# POKA-YOKE SHEET

**BEND PROBLEM**

**SEC : MACHINE SHOP**

**DATE: 25.10.02**

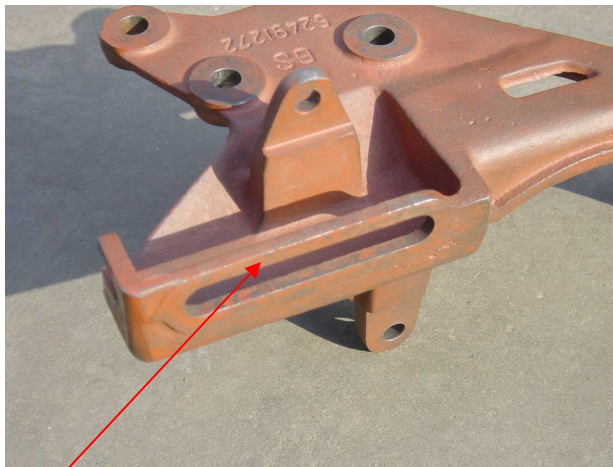
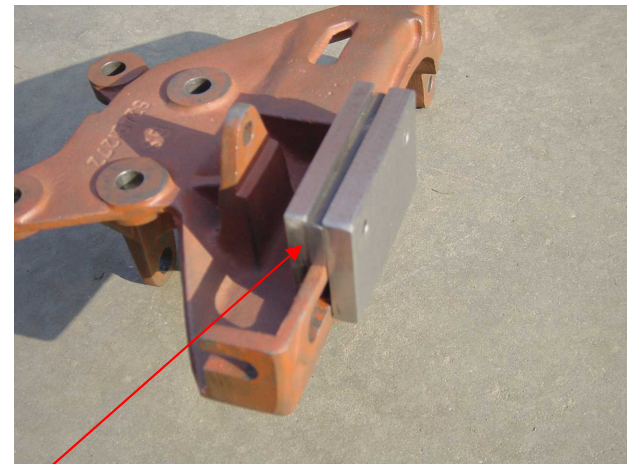
**BENDING OF PULLEY MOUNTING AREA (RIB)  
OCCURES DURING PROCESSING IN CMB-DELPHI  
(CUSTOMER COMPLAINT).**

**No provision to detect the bending problem at pulley mounting area.**

**Special Gauge is provided to detect the bending problem. (Bend Pcs will not answer in the gauge.)**
